# Memorandum

TTPP REF: 20396

#### RE: 55 BAY STREET, DOUBLE BAY RESPONSE TO COUNCIL RECOMMENDATIONS

#### Figure 1: View to Bay Street from within Existing Loading Dock

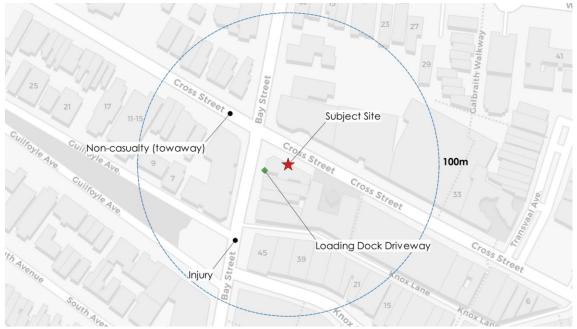
In addition, the existing loading dock was previously approved based on the layout where pedestrian sight triangle requirements as per AS2890.1 are not provided. The existing layout is shown in Figure 1, which involves a heavy vehicle reversing from the loading dock.

Figure 5: Nearby Traffic Calming

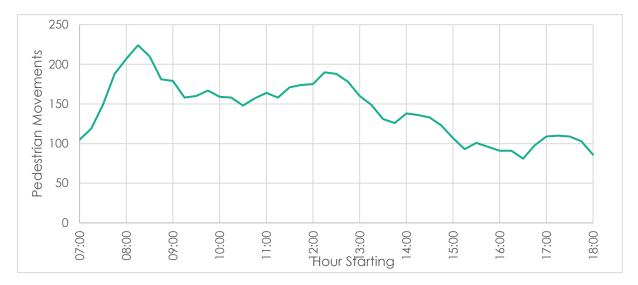
Low travel speeds in the area are partly attributed to the two raised pedestrian crossings at the intersection of Bay Street-Cross Street. The raised pedestrian crossings function as a traffic calming measure, reducing travel speed and inherently increasing drivers' alertness to their surroundings. The raised pedestrian crossing on Bay Street is located only 10 m away from the site access driveway which is shown in Figure 5.

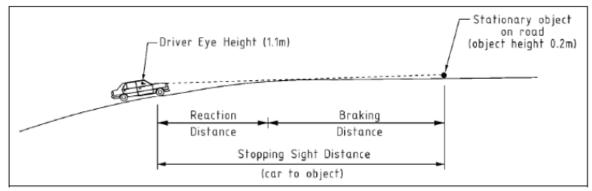
The stopping sight distance is used to calculate the distance required to stop safely to an observed unexpected object. The concept is shown in Figure 7.

#### Figure 11: Tandem Car Stacker Operation

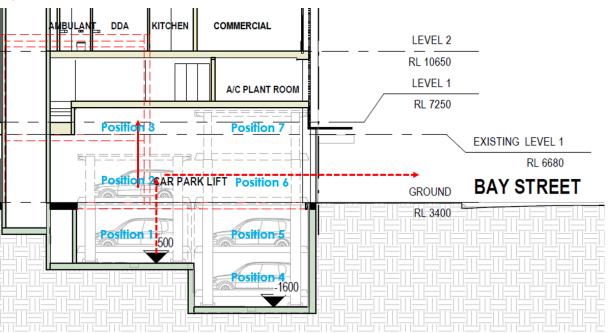
- for the U-10 unit having one vacant space in Position 3 (Figure 11: ): 30 seconds up, 30 seconds down.
- for the U-20 unit having two vacant spaces in Position 6 and Position 7: 60 seconds total up, 60 seconds total down for two levels.

- Lift Run = Position 4 up to Position 6 (vehicle received), then down to Position 5 (next vehicle received) = 60 seconds + 30 seconds = 90 seconds total (worst case scenario)
- Lift service rate: 40 vehicles / hour.
